Office Action Summary	Application No. 10/568,787	Applicant(s) EMBLIN, ALAN GAYNE	
	Examiner JESSIE FONSECA	Art Unit 3633

DETAILED ACTION

Claim Rejections - 35 USC § 102

Fig. 1: Van Loghem et al. (US 3,688,460)

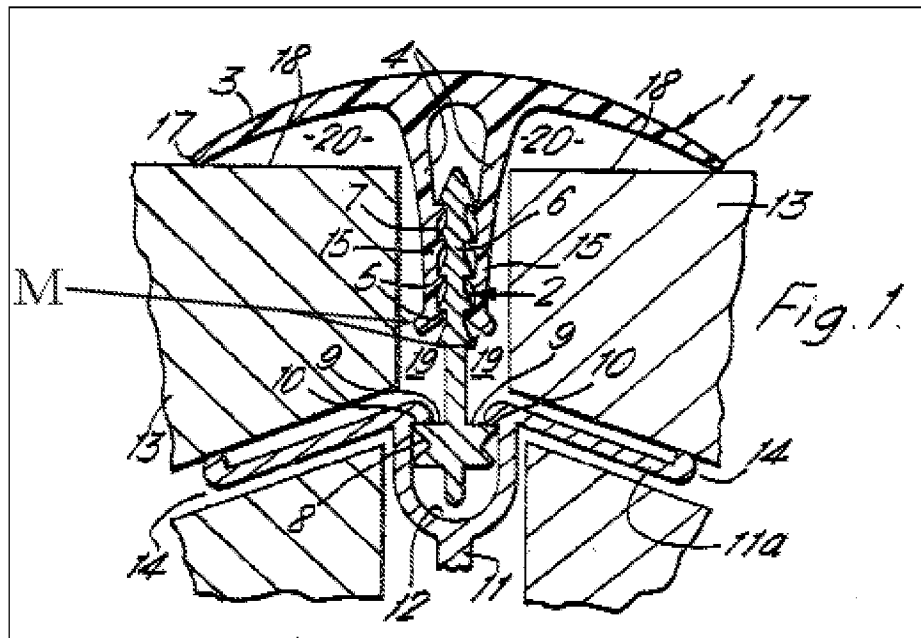
With regard to claims 60, 63, and 68: Van Loghem et al. discloses a stud (1) capable of use in panel form work for solid filled walls, the stud comprising:

a head (3) formed as a strip (figs. 1-2) capable of being bonded and/or fastened to an inner face of a panel facing sheet,

a pair of spaced, opposed flanges (4) formed along and extending away from a central portion of the head (3) the flanges defining a recess with inwardly directed teeth (5) capable of engagement of a spacer element, and

each flange (4) having an out-turned terminal lip (M) to guide passage of the spacer element into the recess.

With regard to claim 61: Van Loghem et al. discloses the width of the head (3) is substantially greater than the spacing of the teeth (5) of the flanges on the central portion of the head (3).

With regard to claim 65: Van Loghem et al. discloses two or more teeth (5) extending longitudinally along each flange (5) inside the recess (figs. 1-2).

With regard to claim 74: Van Loghem et al. further disclose the out-turned terminal lips (M) define a lead-in path for aligning a tongue of the spacer element (fig. 1).

With regard to claim 75: Van Loghem et al. further disclose the out-turned lips (M) define a widening of the recess (fig. 1).

Fig. 3: Durbin (US 4,254,932)

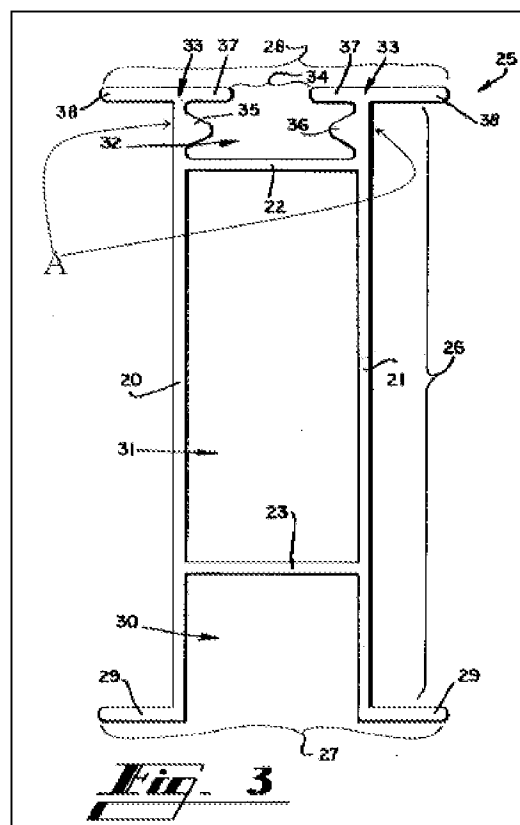
With regard to claims 60, 63, and 68: Durbin discloses a stud (25) capable of use in panel form work for solid filled walls, the stud comprising:

a head (22) formed as a strip (fig. 1) capable of being bonded and/or fastened to an inner face of a panel facing sheet, and

a pair of spaced, opposed flanges (A) formed along and extending away from a central portion of the head (22) the flanges defining a recess (32) with inwardly directed teeth (37) capable of engagement of a spacer element. Examiner notes the central portion of the stud/base is interpreted to be the middle portion along the longitudinal length of the stud.

Durbin discloses each flange (A) has an out-turned terminal lip (38) (fig. 3) capable of guiding passage of the spacer element into the recess.

With regard to claim 61: Durbin discloses the width of the head (20-21, 23, 29) is substantially greater than the spacing of the teeth (37) of the flanges on the central portion of the head.

With regard to claim 65: Durbin discloses two or more teeth (35-37) extending longitudinally along each flange (A) inside the recess (fig. 3).

With regard to claim 67: Durbin further discloses the head, flanges and teeth are formed integrally as an extrusion (fig. 3). Note that head, flanges and teeth being formed from extrusion is considered product by process.

Applicant argues the structure shown in Durbin would not act as a guide passage but would impede passage of the spacer in the channel.

Examiner submits the spacer element nor its configuration is claimed. As the channel provides a passage, Examiner maintains the passage is capable of guiding a spacer element in recess.

Fig. 3A: Dunn et al. (US 2002/0124508 A1)

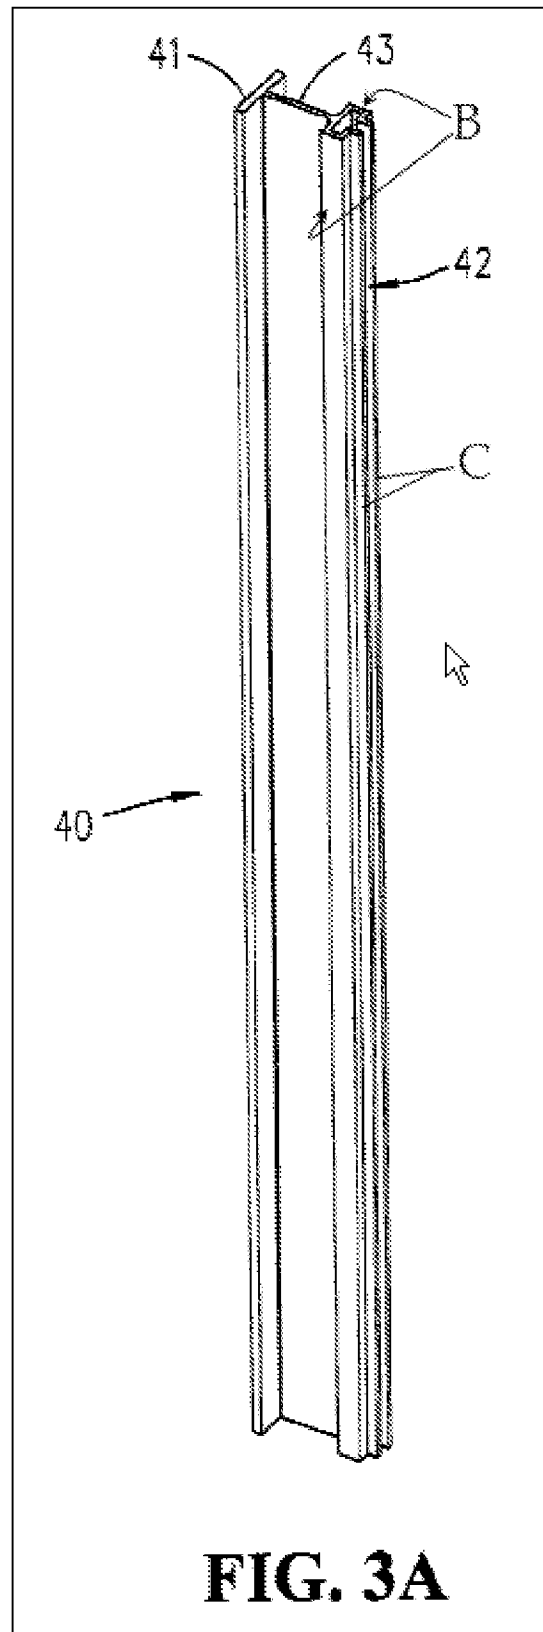
With regard to claims 60, 63, and 68: Dunn et al. discloses a stud (40) capable of use in panel form work for solid filled walls, the stud comprising:

a head (41) formed as a strip (fig. 3A) capable of being bonded and/or fastened to an inner face of a panel facing sheet, and

a pair of spaced, opposed flanges (B) formed along and extending away from a central portion of the head (41), the flanges (B) defining a recess with inwardly directed teeth (inwardly turned flanges) capable engagement of a spacer element.

Dunn et al. discloses each flange has an out-turned terminal lip (C) capable of guiding passage of the spacer element into the recess.

With regard to claim 62: Dunn et al. discloses the width of the head (41) is approximately seven times the spacing between the teeth (inwardly turned flanges) of the flange on the central portion of the head.

With regard to claim 64: Dunn et al. further discloses a cross sectional configuration, formed by the strip and the pair of flanges, which is substantially T-shaped (fig. 3A).

With regard to claim 67: Dunn et al. further discloses the head, flanges and teeth are formed integrally as an extrusion (fig. 3A). Note that head, flanges and teeth being formed from extrusion is considered product by process.

With regard to Dunn et al., Applicant argues the flanges (B) are not “formed along and extending away from a central portion of the head”.

Applicant further argues the inwardly turned flanges and the flanges (C) of Dunn et al. refer to the same element.

Examiner disagrees, the head (41, flange) extends in a parallel orientation with the flanges (B), therefore meeting the limitation of the flanges being formed along the

head, where the flanges extend away from the central portion of the head (fig. 3A).

Examiner suggests amending the claims to further define how the flanges are formed along the head of the stud.

Examiner disagrees, the flanges (C) are not inwardly turned, but instead extend from the inwardly turned flanges to which they are perpendicular to as shown in fig. 3A.
